MEMORANDUM

To: The Design Advisory Board
From: Mary O'Neil, AICP, Principal Planner
RE: ZP21-639; 48-50 Greene Street
Date: September 14, 2021

File: ZP21-639
Location: 48-50 Greene Street
Zone: RM **Ward:** 2C
Parking District: Neighborhood
Date application accepted: August 31, 2021
Applicant/ Owner: Lee Bissonette
Request: "Repair of Fire Escape"
Site visit: September 8, 2021

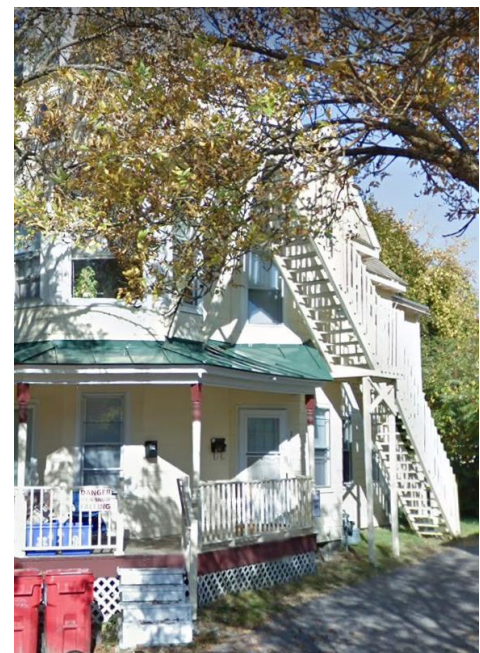
The application is an after-the-fact permit to “repair” an exterior stair originally erected in 1984. The design of the stair, which rises from the ground level to the third story has been altered by the addition of a support column between the first floor porch and the third floor landing. The contractor has carried the weight of the upper deck landing down onto an iron plinth, mounted through the

second floor porch roof, continuing to a porch mounted iron-angle. The design is awkward on this historic

structure; may overly burden the first floor porch deck (the porch lattice shows deflection) and hinders escape from the second floor turret window.

The egress stair replaces another installed in 1984. In that manner, the visually intrusion is similar. The earlier stair did not have the additional porch support which is obtrusive and especially visible from the public right-of-way.

The piercing of the porch roof introduces an opening in the building envelope that will

invite water and early rot. The solution was ill-advised from the standpoint of building care and protecting the character defining features of the building.

The stairs themselves appear to be in the same location as the previous stairs; but the iron support pole that rises vertically through the first floor porch roof is a visual intrusion that is particularly damaging to the porch and to the integrity of the historic structure.

The alteration of features; specifically the inclusion of an iron support post on the (visible) front porch, is an unacceptable and avoidable alteration to the character of the historic structure.

Providing additional support by introducing non-historic materials on a façade visible from the street is a physical treatment that mars the historic character of the structure. Piercing the first floor porch roof for the iron column is a physical treatment that has caused damage to historic building fabric, and portends additional damage with exposure to the elements.

The method of support for this replacement staircase is distracting and is an adverse alteration to the historic porch/house. It can and should be removed and a different solution sought to protect the historic integrity of the residence.
